December 10, 2008. Item 13. Supporting Document

NOTICE OF HEARING AND ISSUANCE OF COMPLAINT NO. R9-2008-0057 FOR ADMINISTRATIVE CIVIL LIABILITY AGAINST SANTA MARGARITA WATER DISTRICT FOR VIOLATION OF ORDER NOS. 2006-0003-DWQ AND R9-2007-0005

**Santa Margarita Water District
Technical Report
Ortega Force Main and Sewer Spill
April 5 through April 8, 2007**

Santa Margarita Water District Sewer Break Assessment
Impacts at the Site of Broken Sewer Line on Rancho Mission Viejo Near Cristianitos Creek

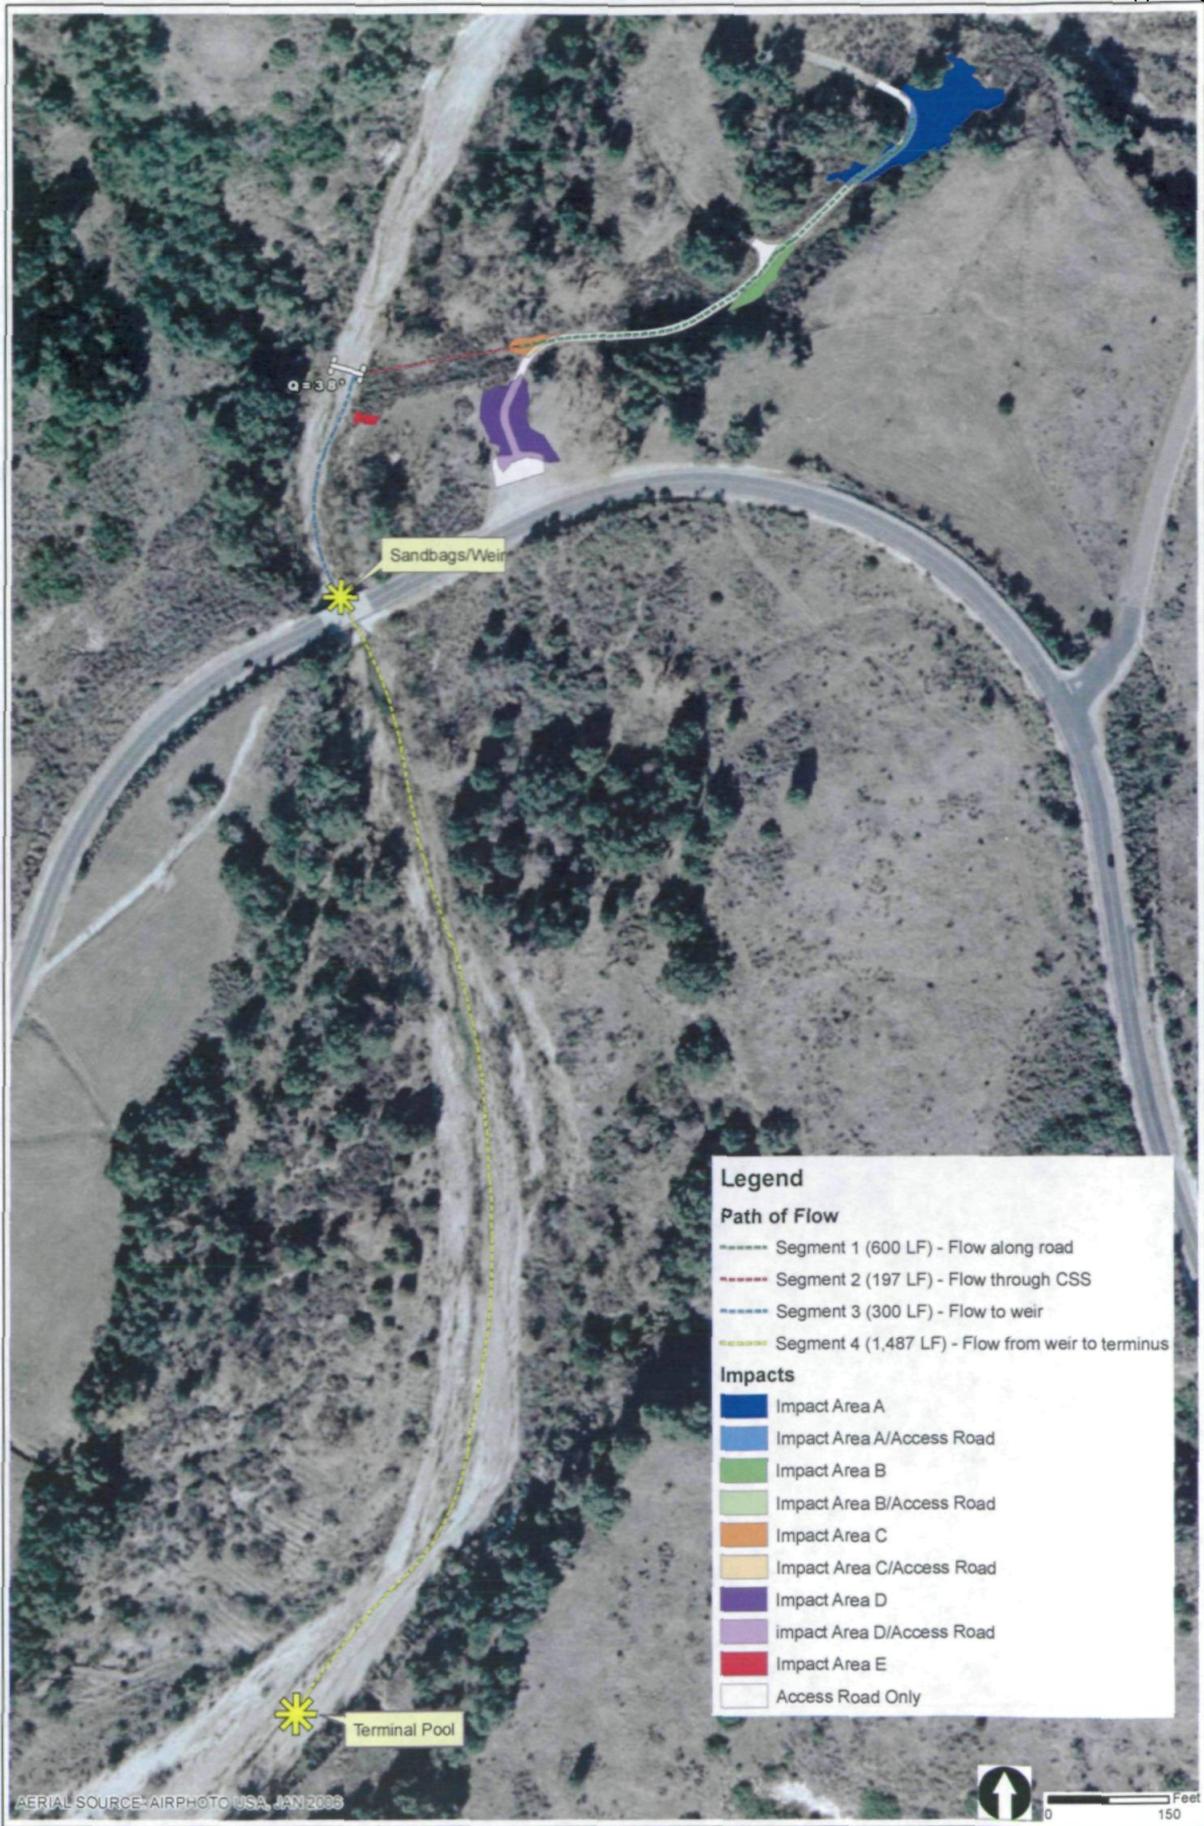
7. *Please provide a written explanation for why "excess fill and gravel from the lay-down area was pushed into the Cristianitos Creek (Figure 3, Area E) within an opening in some mulefat"? Why were "sandbags containing gravel... emptied into the stream channel"? (page 2 of Dudek report, 4th paragraph, last sentence)*

2. At the site of the excess material dump (*Figure 3, Area E*) Mulefat Scrub:
 - Remove non-native soil and gravel.
 - Re-create the stream bank pre-construction contours.
